Access Compliance Report

Public Rights-of-Way

(Curb Ramps)

Intersection ID: 50998	Main Street: S_TRYON_ST	Cross Street: STEELECROFT_PY	Location: NW
ADA ID: 0457CE0B7BEB	Ramp Type: Perp	Initial Pass/Fail: Fail	Overall Compliance: No
Severity Score: 35			
Codes/Mitigation Info/Possible Solution		Field Measurements/Component Compliance

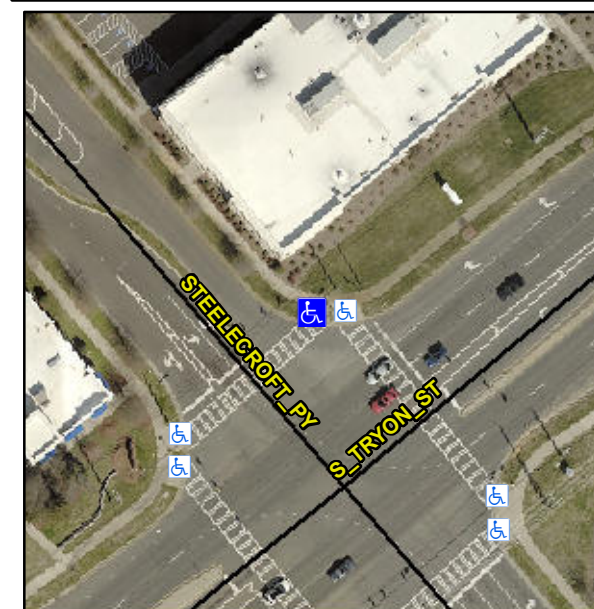
Not Found, R304.5.1, R304.2.2

Compliance	Description	Data	Compliance	Description	Data
N/A	Ramp Length (in)	97.0	No	Ramp Slope (%)	12.1
No	Ramp Width (in)	45.5	Yes	Ramp XSlope (%)	4.7
N/A	Flare Type LT	N/A	N/A	Flare Type RT	N/A
N/A	Flare Slope LT (%)	N/A	N/A	Flare Slope RT (%)	N/A
N/A	Flare Traversable LT?	N/A	N/A	Flare Traversable RT?	N/A
N/A	Landing Length (in)	N/A	N/A	DWS Provided?	N/A
N/A	Landing Width (in)	N/A	N/A	DWS Contrast?	N/A
N/A	Landing Slope (%)	N/A	N/A	DWS Length (in)	N/A
N/A	Landing X Slope (%)	N/A	N/A	DWS Full Width?	N/A
N/A	Landing Curb? (Y/N)	N/A	N/A	DWS Offset (in)	N/A
N/A	Shared Landing?	N/A			
N/A	Gutter Ponding?	N/A	N/A	Gutter Slope (%)	N/A
N/A	Gutter Lip Ht (in)	N/A	N/A	Gutter X Slope (%)	N/A
N/A	Painted X Walk1?	Yes	N/A	Painted X Walk2?	N/A
	X Walk 1 Direction	To SW		X Walk 2 Direction	N/A
N/A	X Walk 1 Width (in)	111.0	N/A	X Walk 2 Width (in)	N/A
	X Walk 1 Slope (%)	2.0		X Walk 2 Slope (%)	N/A
	X Walk 1 X Slope (%)	4.8		X Walk 2 X Slope (%)	N/A

Remove & Replace Entire Ramp.
